Product Announcement

New Improved Drum for Brake Applications

Manaras-Opera New Improved DRUM 004

Drum 004 ▶▶▶

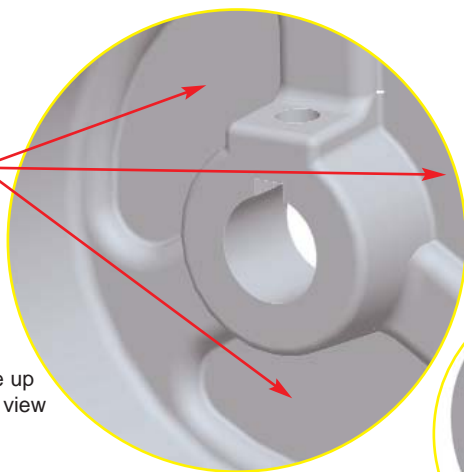
Responding to your needs, Manaras-Opera has made an improvement to its drum used on operators with a brake.

- A new backing has been added to the drum in order to help prevent any brake or belt dust from penetrating the motor's ventilation holes.
- A decrease in dust helps to prevent a malfunction of the motor's centrifugal switch.
